DELRAY BEACH COMMUNITY REDEVELOPMENT AGENCY (CRA)
INVITATION TO BID (ITB) CRA NO. 2025-03
EXTERIOR AND INTERIOR REPAIRS TO THE CRA-OWNED BUILDING
LOCATED AT 313 NE 3rd STREET – ARTS WAREHOUSE

ISSUE DATE
July 3, 2025

CONSTRUCTION DOCUMENTS

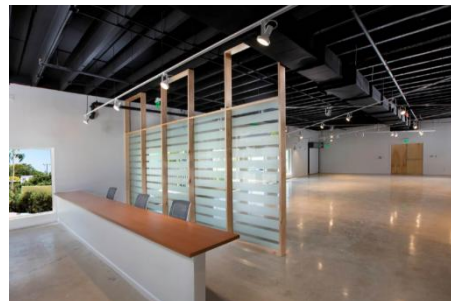
See below picture of the referenced desk/pony wall.

3
A3.1 PARAPET DETAIL

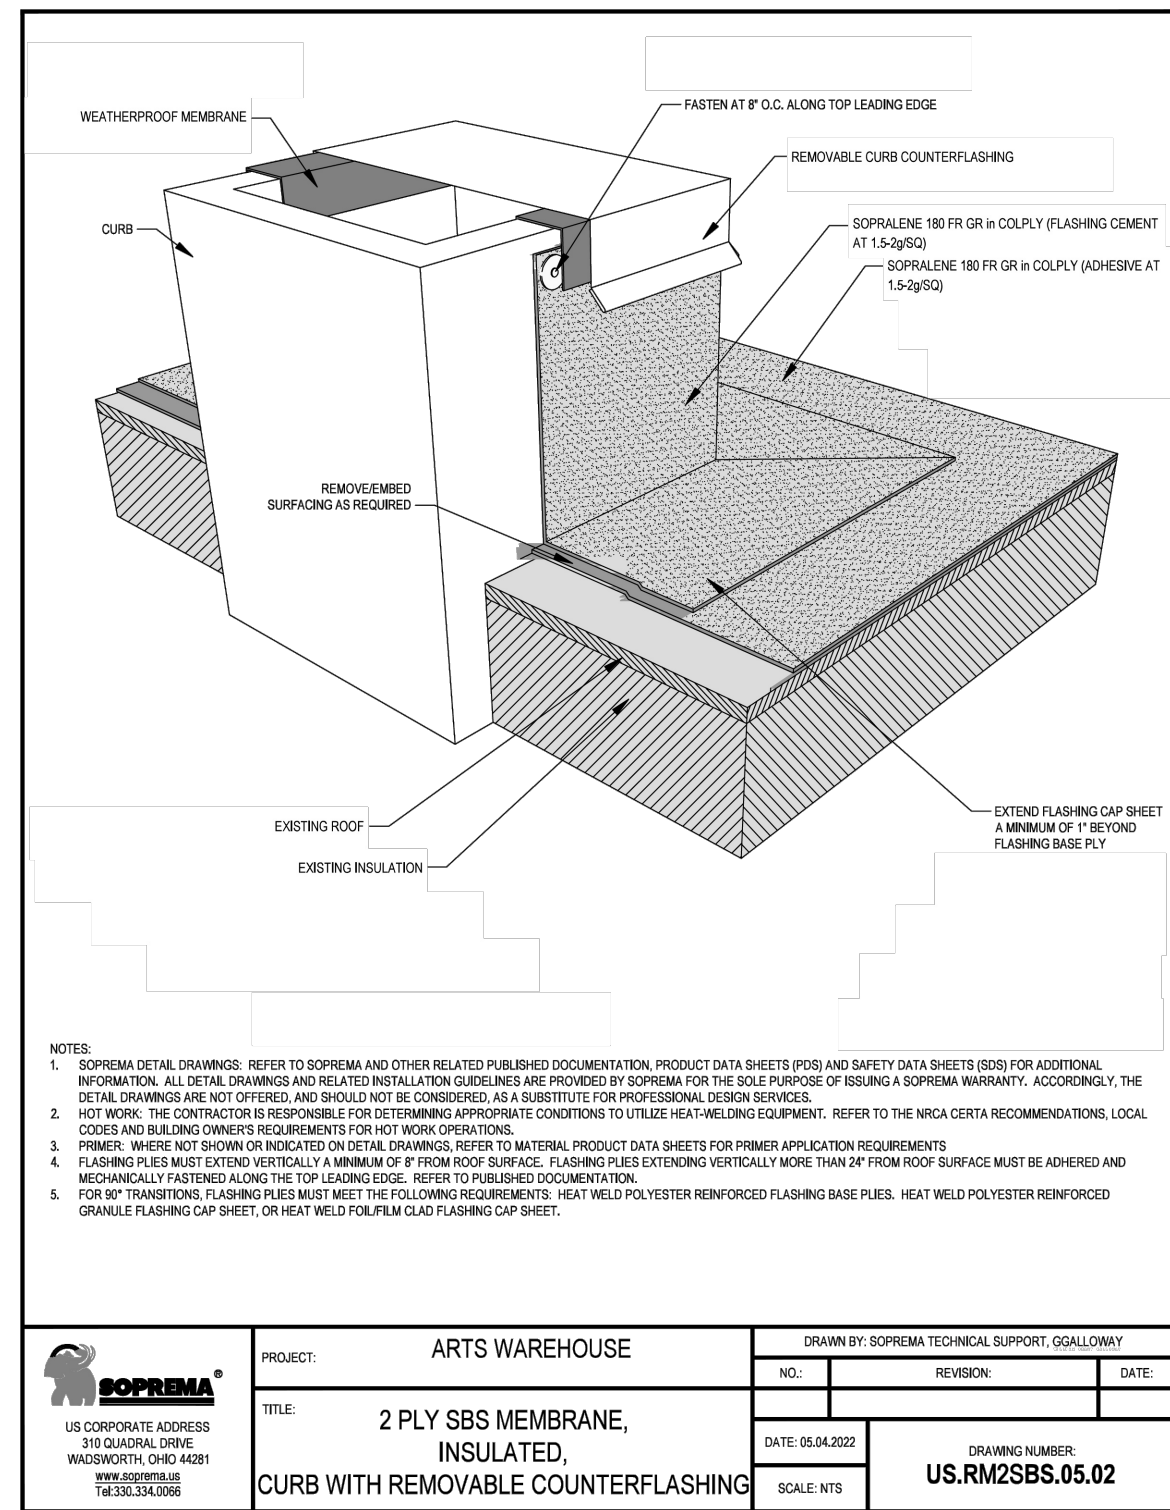
15. **Parapet detail 3 on Sheet 3.1 states replace would blocking as needed. Do you have the size of the blocking (detail is not to scale)? To bid accurately should we provide a unit price?**

All blocking shall be 2x P.T. material as shown in the detail the exact width shall be determined by the Contractor in the field to match the existing wall thickness (2x8 would most likely be required). Contractor to confirm final dimension once exposed after demolition.
